## ArevaEPRDCPEm Resource

The attached file, "RAI 371 Supplement 25 Response US EPR DC - Interim.pdf" provides an updated INTERIM response to Question 03.07.02-66 Part (b). Appended to this file are affected pages of the U.S. EPR Final Safety Analysis Report in redline-strikeout format which support the response to RAI 371 Question 03.07.02-66 Part (b).

**Question 03.07.02-66:**

Figure 3.7.2-151—Solid Element Basemat

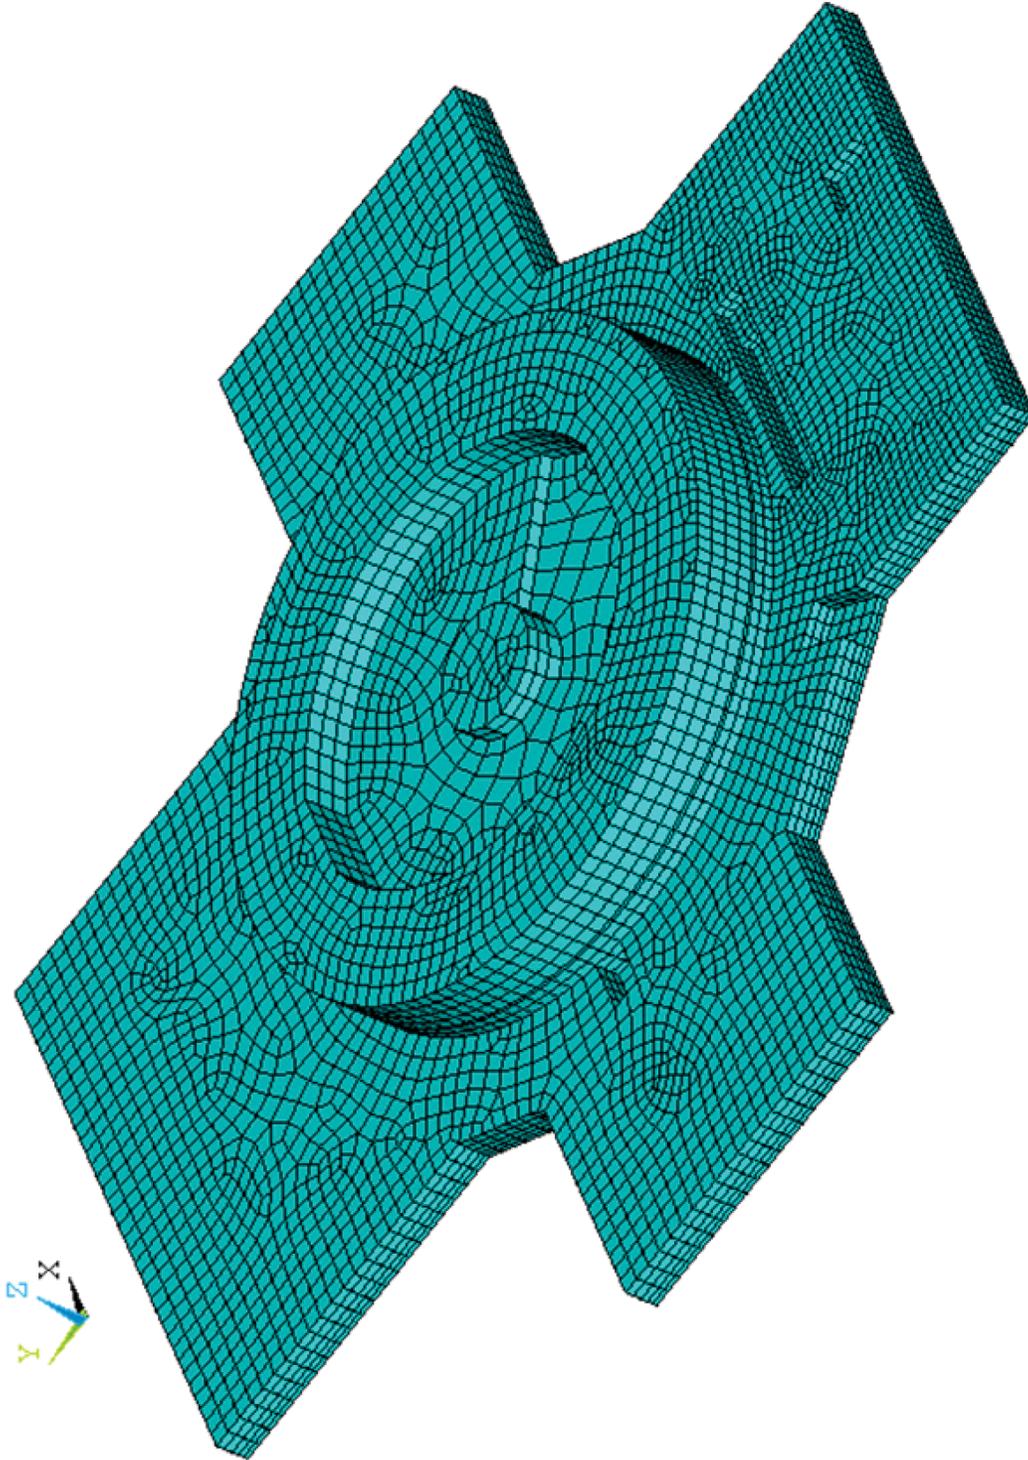
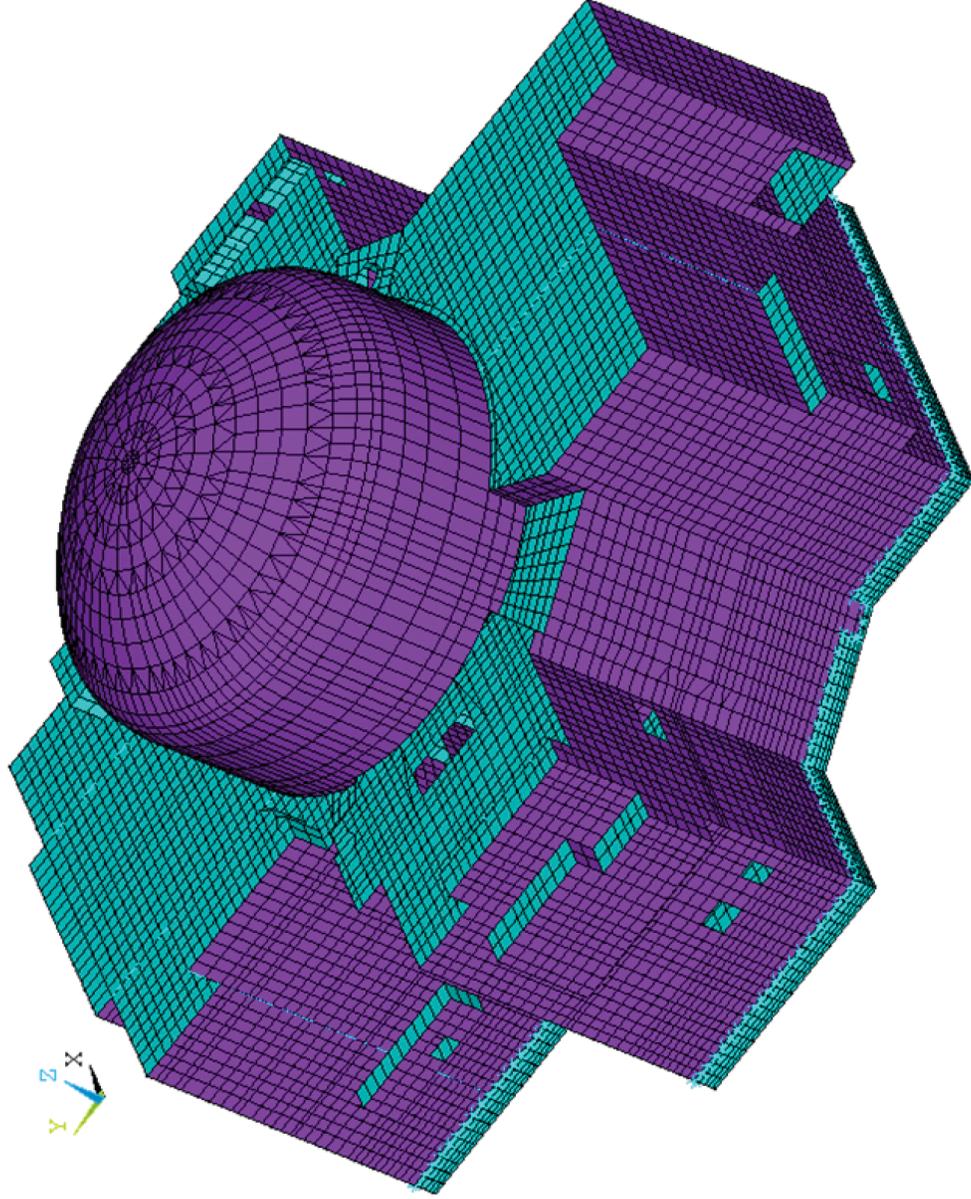
03.07.02-66

U.S. EPR FSAR Tier 2, Section 3.7.2.3.1.4 and Figures 3.7.2-151 and 3.7.2-152 will be added as described in the response and indicated on the enclosed markup.

ANSYS SOLID45 solid elements are used to model the concrete basemat foundation in the NI Common Basemat Structure static analysis. SOLID45 is a three-dimensional, eight-node element that is suitable for moderately thick structures. Depending on the thickness of the basemat, between three to five layers of SOLID45 elements are used in the model, with an average of four elements in the typical 10 feet thick basemat areas. Figure 3.8-103—Nuclear Island Common Basemat Structure Foundation Basemat ANSYS Model illustrates the model used for design of the basemat.
